PG&E Letter DCL-15-142

Response to NRC Letter dated November 5, 2015, "Request for Additional Information Related to the Environmental Review of the Diablo Canyon Power Plant, Units 1 and 2, License Renewal Application (CAC Nos. MF4019 and MF4020)"

Pacific Gas and Electric Company's Response to Nuclear Regulatory Commission's "Request for Additional Information Related to the Environmental Review of the Diablo Canyon Power Plant, Units 1 and 2, License Renewal Application," dated November 5, 2015

Figure AIR-7-28

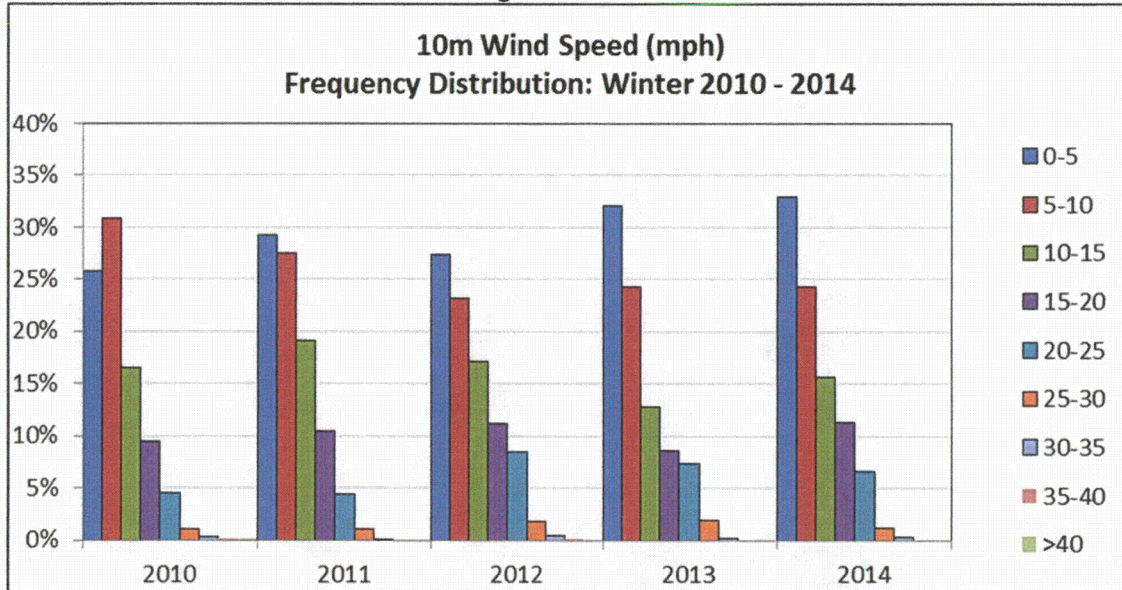
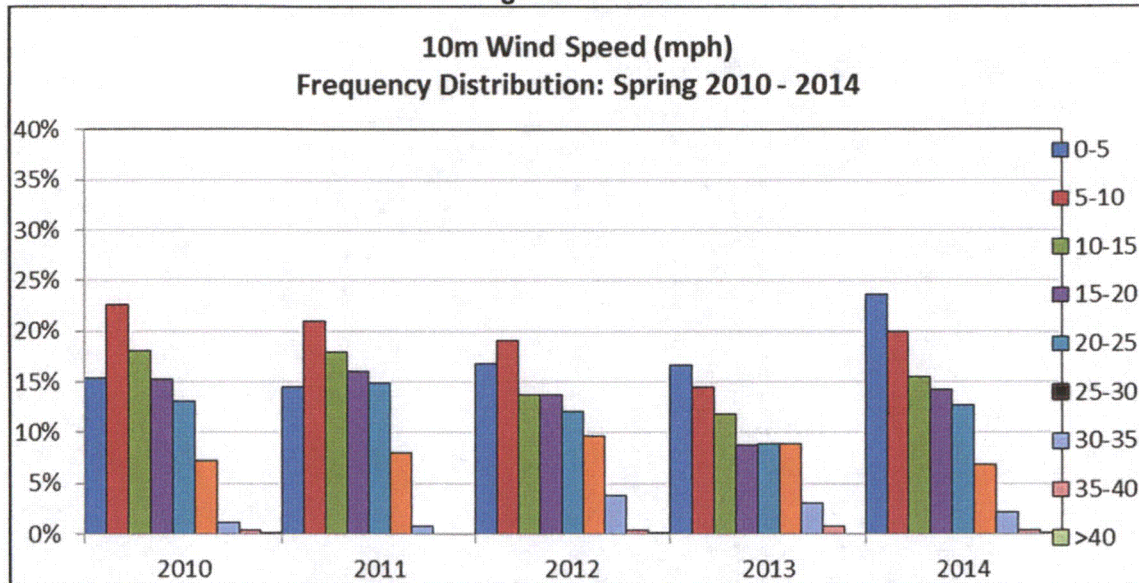
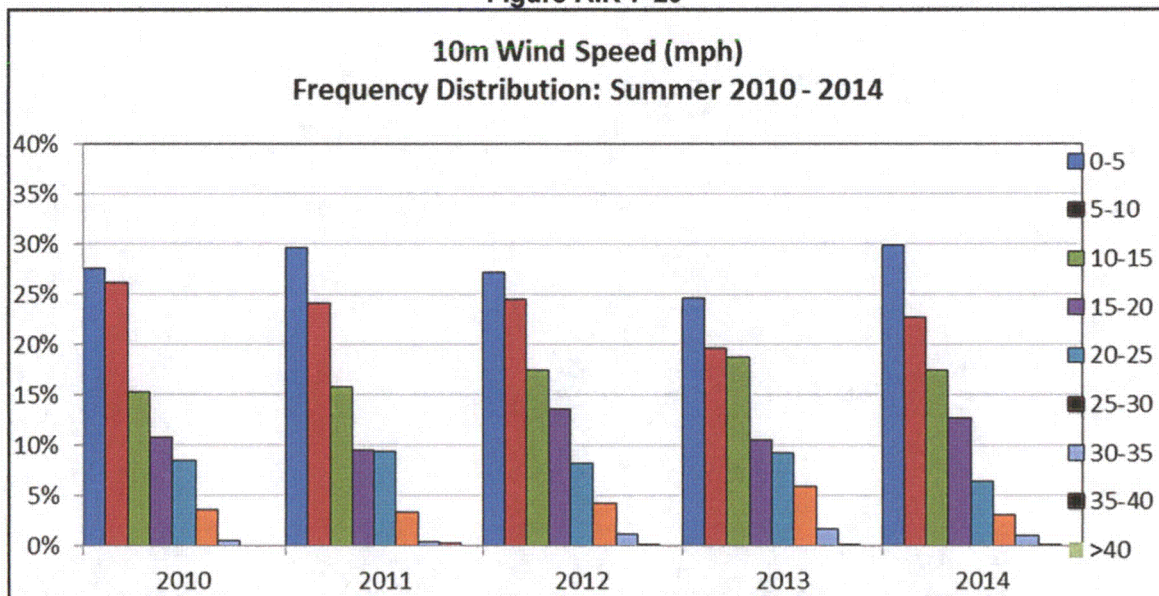
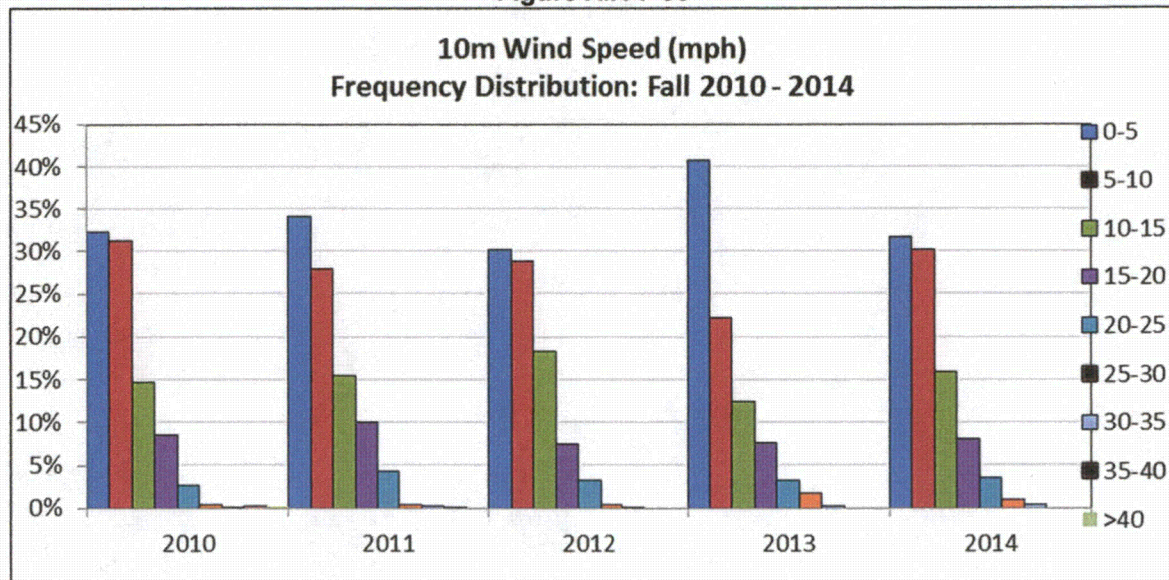
Provide seasonal and annual summary wind statistics in the form of wind direction and speed frequency distribution tables and wind roses from data recorded at DCP's meteorological facility. Discuss predominant wind direction and speed by season and annual average. The meteorological data should include the most recent 5 years for which the data are available.

The annual and seasonal wind direction frequency of occurrence for the DCP primary tower 10-m level for the period 2010 to 2014 are presented in Attachment 2, Tables AIR-7-1 through AIR-7-5. Annual and seasonal wind roses for DCP for the 2010 to 2014 periods are presented in Attachment 1 Figures AIR-7-1 through AIR-7-25. The wind rose presents the joint frequency of wind speed and wind direction recorded at the 10-m level at the plant. The wind direction is presented in 16 principal directions (north, north-northeast, northeast, north northwest) with each direction category encompassing a 22.5-degree sector centered on that direction. Six wind speed categories are used with the lower bounds at 0.1, 3.5, 6.9, 11.5, 18.4, and 24.2 miles per hour (mph). The length of each color band represents the frequency of a specific wind speed range. For example, northwesterly winds greater than 24.2 mph occurred 4.1 percent of the time for the period 2010 to 2014. Furthermore, below each wind rose diagram, is the same data displayed in table form for a more detailed breakdown of the seasonal wind direction and speed frequency distribution.

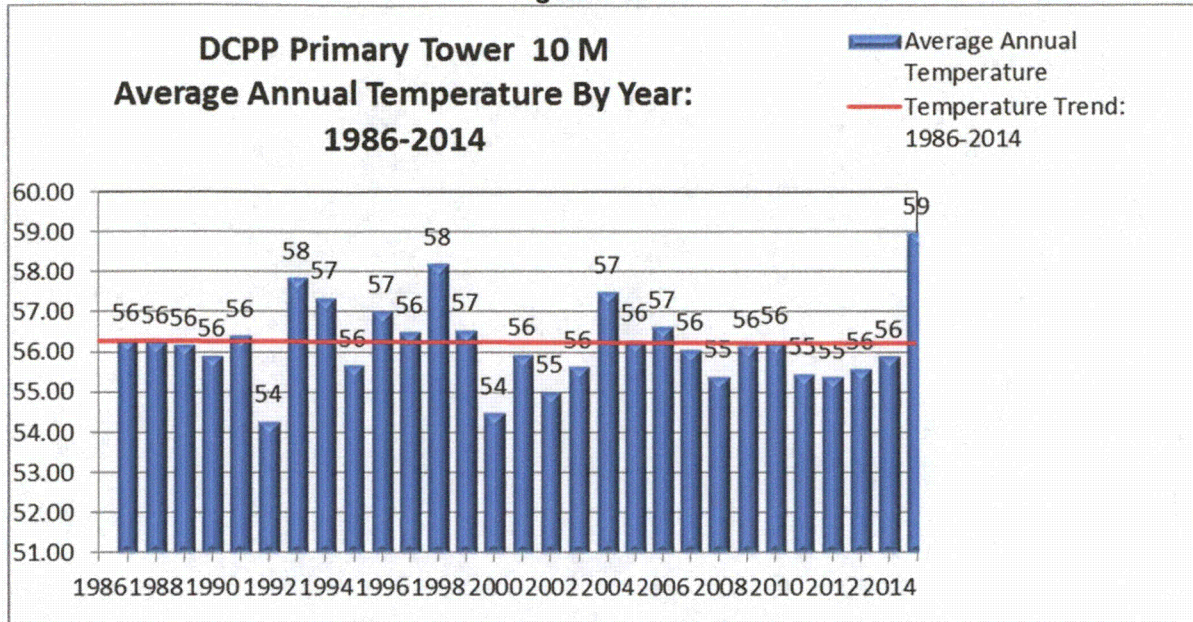
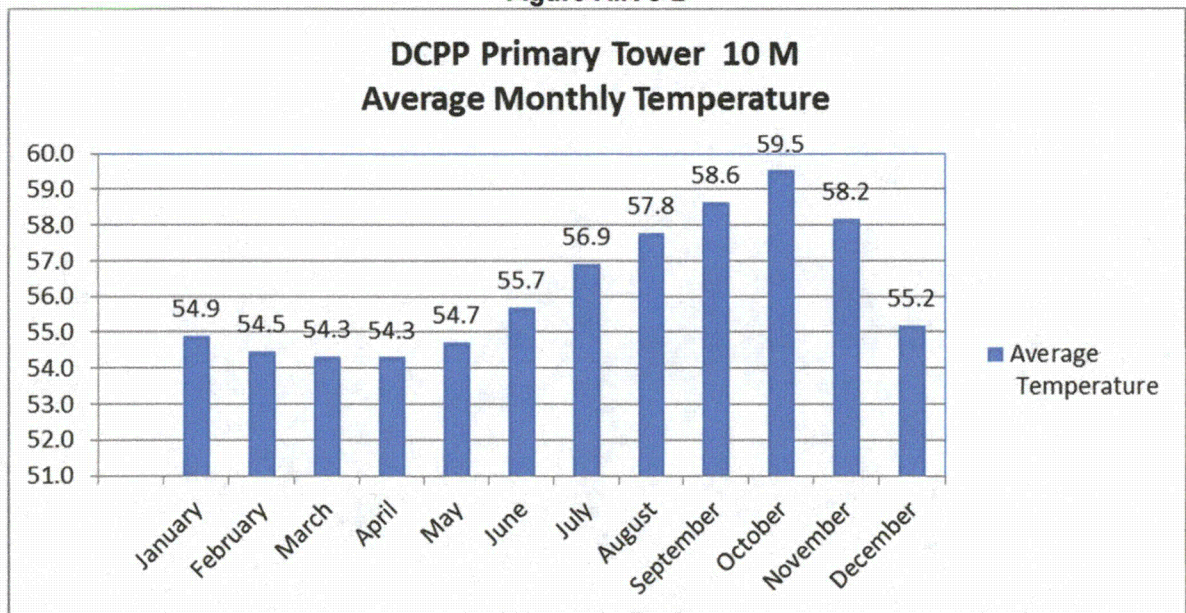
In support of the NRC staff's greenhouse gas, climate change, and cumulative impacts analysis, provide the following long-term meteorological information from the data recorded at DCP's meteorological facility and address if an ambient temperature and precipitation trend (i.e. increase/decrease, warming, etc.) has been observed at DCP. The meteorological data should include all years for which the data are available:
